August 9, 2012

California Energy Commission
Dockets Office, MS-4
Docket No. 09-RENEW EO-01
1516 Ninth Street
Sacramento, CA 95814-5512

Subject: Comments on DRECP July 25 and 26, 2012 Stakeholder Meeting Materials
Docket Number 09-RENEW EO-01

Figure 1: Soda Mountain Solar Reserve Classification

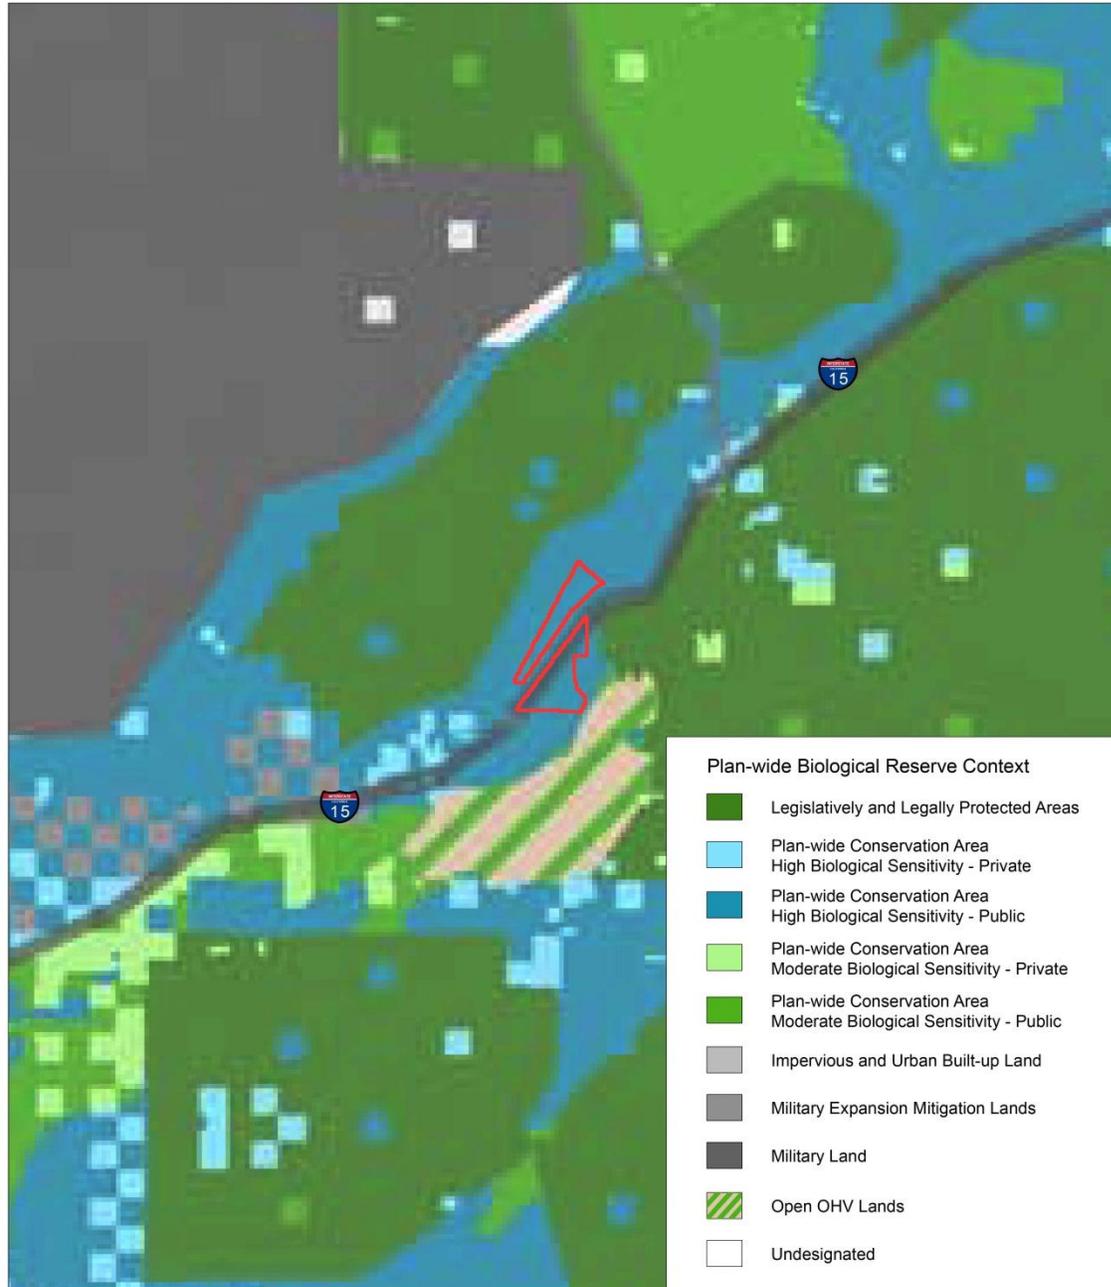
Although the DRECP is a landscape-scale endeavor, more detailed regional and local species specific analyses should replace large scale modeling based on habitat naturalness.² In this instance, the Project site is designated as “Plan-wide Conservation Area – High Biological Sensitivity – Public” within the plan-wide biological reserve (Figure 1). The output of the Marxan analysis presented in the meeting materials showed a moderate biological sensitivity for the Project site (DRECP 2012a). The elevation to high biological sensitivity was therefore an output of the expert-based analysis. The high biological sensitivity designation indicates that the area contains biological resources that are sensitive to perturbation, high concentrations of biological resources, or highly sensitive biological resources. However, as explained below, neither a High Biological Sensitivity nor a Moderate Biological Sensitivity designation is consistent with the multiple Project-specific, habitat and focused species field surveys that have been on file with the BLM under right-of-way application CACA-49584 since 2009.³

The reserve design that resulted from Marxan Scenario 5 displayed the Project site as a green area of moderate biological sensitivity and therefore an area considered for conservation according to the DRECP. As stated by the BLM during the stakeholder meeting on July 25, 2012, this sensitivity was based largely upon land cover naturalness; species-specific biological goals and objectives were not developed or considered. Naturalness is an inaccurate proxy for species habitat and use. Species niche habitat and connectivity reflect landscape population dynamics that are independent of the naturalness of the habitat, for example. Areas of high “naturalness” may be unsuitable for species use for a variety of reasons: areas with few impervious surfaces may be unsuitable for niche habitat preferences, other factors may have contributed to habitat degradation (e.g., predators, invasive species), or an area may be outside of a species range due to natural or man-made landscape barriers (e.g., mountains, unvegetated playas, highways). Likewise, highly-disturbed habitats may be suitable to species use or contain important corridors, such as riparian areas for connecting wildlife populations. The reserve design does not provide targeted protection of the species that the DRECP is tasked with conserving because detailed, “ground-truthed” species and linkage analysis was not used in the design. Because the reserve design is based on naturalness of habitat, the reserve design reflects very large areas of moderate and high biological sensitivity due to the relatively few developed areas (impervious areas which would not be “natural”) located within the DRECP Area. These areas may not be key habitat or linkage areas for species covered under the DRECP. Therefore, in the absence of detailed species analysis, the Marxan reserve design is unlikely to identify targeted areas for protection because it did not consider the species and uses that need to be protected.

The Project site exhibits low biological sensitivity and should not be designated as a moderate biological sensitivity area. The Project site is highly affected by the presence of I-15 and the existing intensive land uses within the area. Wildlife use of the Project site is limited by the Soda Mountains to the north and south, the Baker sink to the east, and I-15 dividing the Project site. These barriers to wildlife movement and the increased incidence of mortality associated with the highway limit the potential for future wildlife use of the Project site. The Project site does not meet any of the criteria for biological sensitivity and should be categorized as unclassified land (i.e., “conservation unlikely”), particularly when its low biological sensitivity is considered in the context of current disturbance and the site’s designation as a Section 368 transmission corridor and a (biologically ground-truthed) Renewable Energy Transmission Initiative (RETI) Competitive Renewable Energy Zone (CREZ). The reserve design should be modified to designate the Project site as unclassified land.

Figure 2: Soda Mountain Solar “High Conflict Areas”

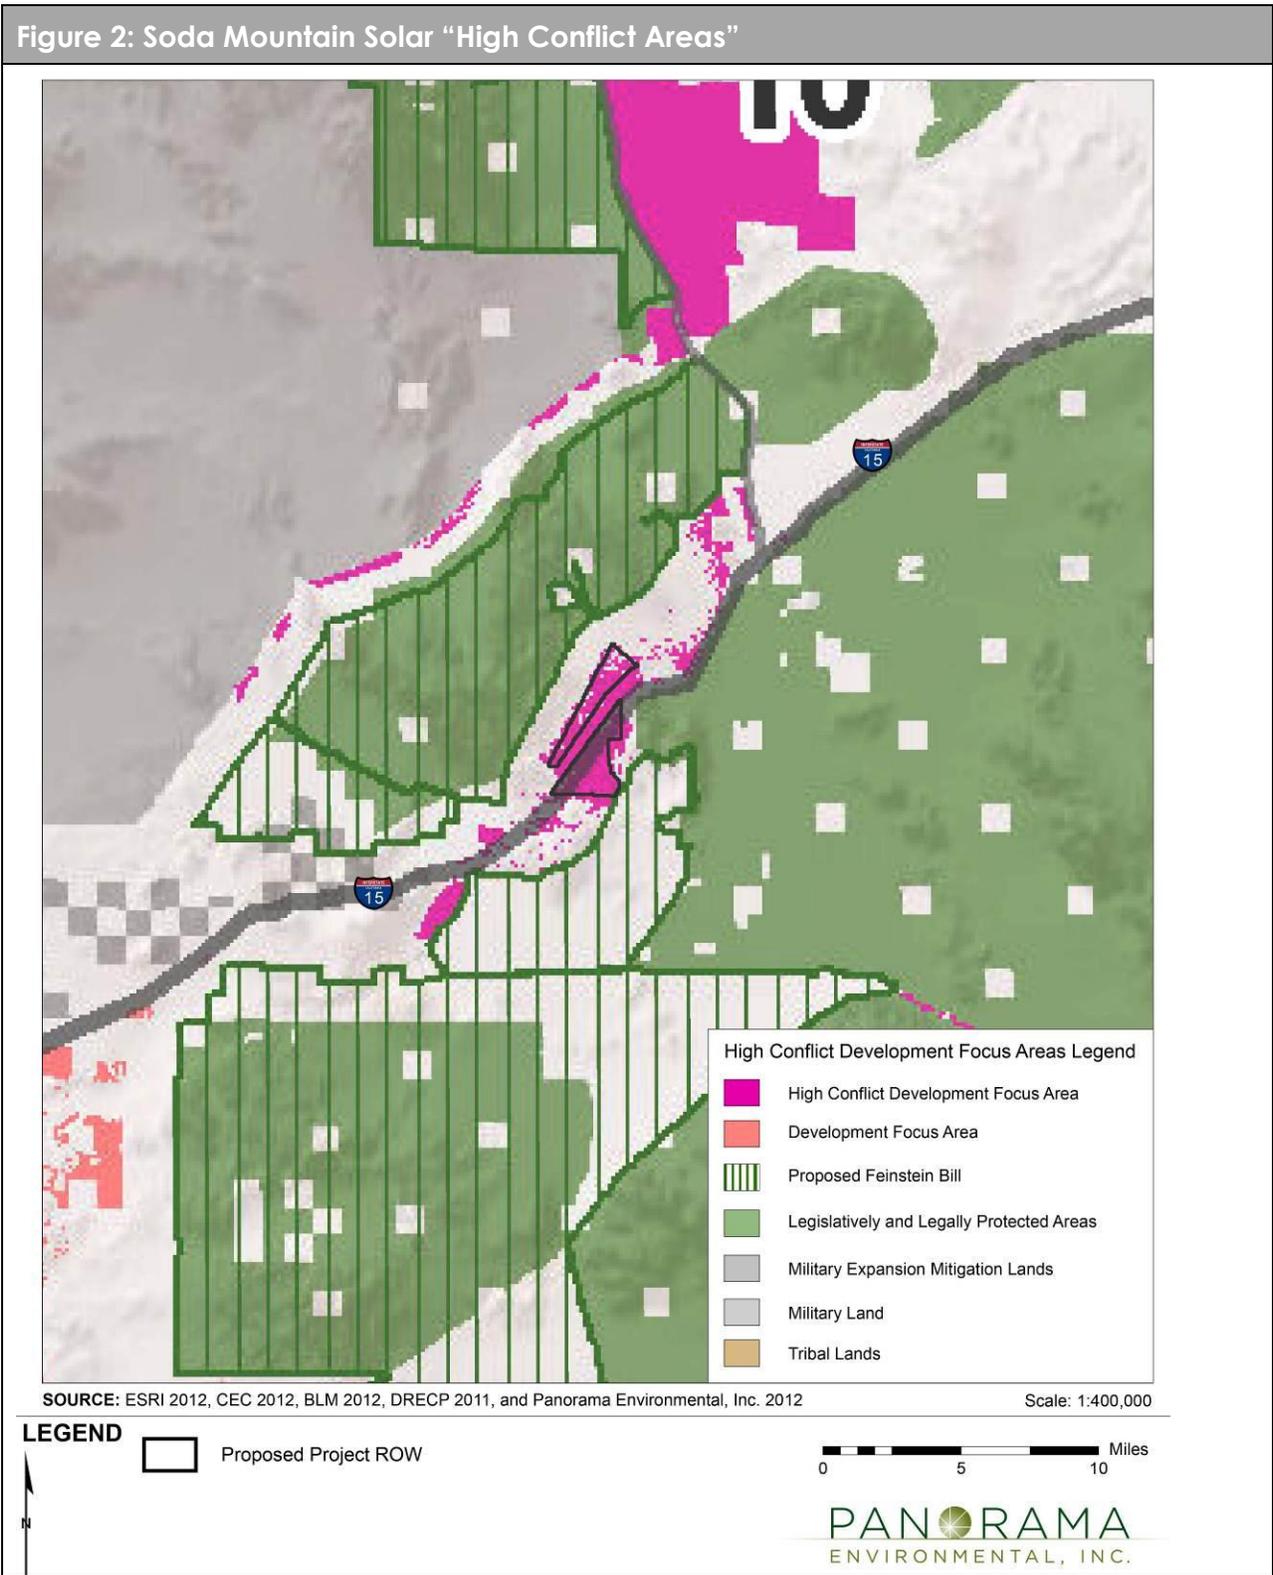
The Project site falls within the “Dinosaur” polygon that was designated as a “high conflict” Development Focus Area (DFA) on the basis of potential biological and public land use planning conflicts. The conflicts identified for the Dinosaur polygon do not apply to the Project site.

The following potential biological conflicts were identified (Figure 2):

- Bighorn sheep (29,326 acres of inter-mountain habitat; 7,390 acres of mountain habitat)
- Desert tortoise (17,583 acres of modeled habitat)
- Mojave fringe-toed lizard (29,821 acres of modeled habitat)
- Habitat linkages (16,117 acres of desert linkages)
- Total number of modeled DRECP Species: 10

The Project site, consisting of approximately 4,400 acres, is included in a larger potentially high conflict area. The majority of the Dinosaur polygon is located north of the Soda Mountains in an area that is geographically separate from and includes different habitat elements than the Project site. The conflicts identified for the Dinosaur polygon do not apply to the Project site. The Project site does not contain Mojave fringe-toed lizard modeled habitat, and, as shown in Figure 3, is not located within any habitat linkages (CEC 2012 and Penrod et al. 2012), or habitat identified by intensive surveys (URS 2009). The modeled results for designating desert tortoise and bighorn sheep habitat inaccurately characterize and overstate the habitat suitability of the Project site because focused surveys for desert tortoise and bighorn sheep are in direct conflict with the model results. The surveys found no desert tortoise on the Project site and a lack of suitable habitat for bighorn sheep. As explained above, the models of desert tortoise and bighorn sheep habitat suitability overstate the habitat quality of the Project site.

In short, the High Conflict Area map needs to be revised to exclude the Project site because the potential biological and public land use conflicts ascribed to the Dinosaur polygon do not apply to the Project site.

1. The categorization for the Soda Mountain Solar Project site should be changed; from "High Biological Sensitivity – Public" to "Unclassified Land";
2. The high conflict DFA designation should be removed from the Project site;
3. The Project site should be identified as a DFA across all development alternatives; and
4. The PEIS "pending projects" exemption should be incorporated into the DRECP design.

Figure 3: Soda Mountain Solar Connectivity Areas (Penrod et al. 2012)

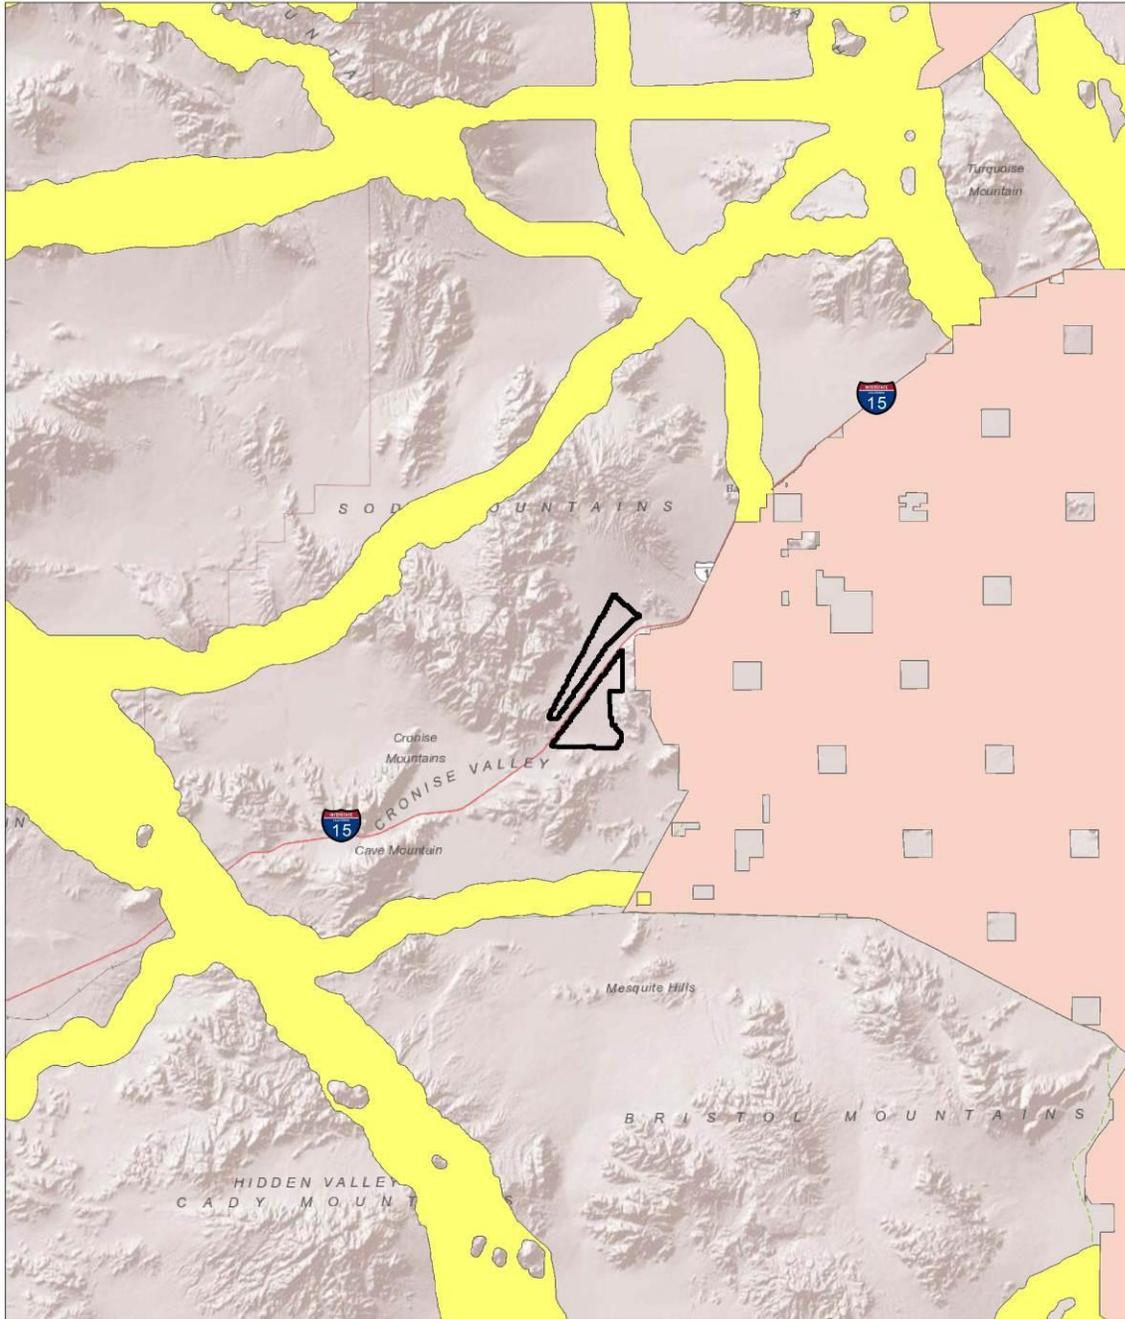
Habitat linkages and corridors	No habitat linkages were identified within the Project site by the Desert Connectivity Project (Penrod et al. 2012). An essential connectivity area was identified within the Project site (REF); however, the essential connectivity areas should be succeeded by the linkages identified in the Desert Connectivity Project (Spencer et al. 2010; Heim and Hietter 2012); see fn 2, above.
Physiographic and environmental representativeness: elevation gradients, slope, aspect, temperature, rainfall, including climate change	The Soda Mountain Solar Project site is contained within a valley where slopes range from 2-4%. The Project site is very uniform in elevation, gradient, rainfall, and temperature due to the overall small size of the Project site (4,400 acres) and the uniformity of site conditions. The habitat within the Project site is also uniform, exhibiting low vegetation and species diversity. The Project site does not include unique or distinct physiographic elements.
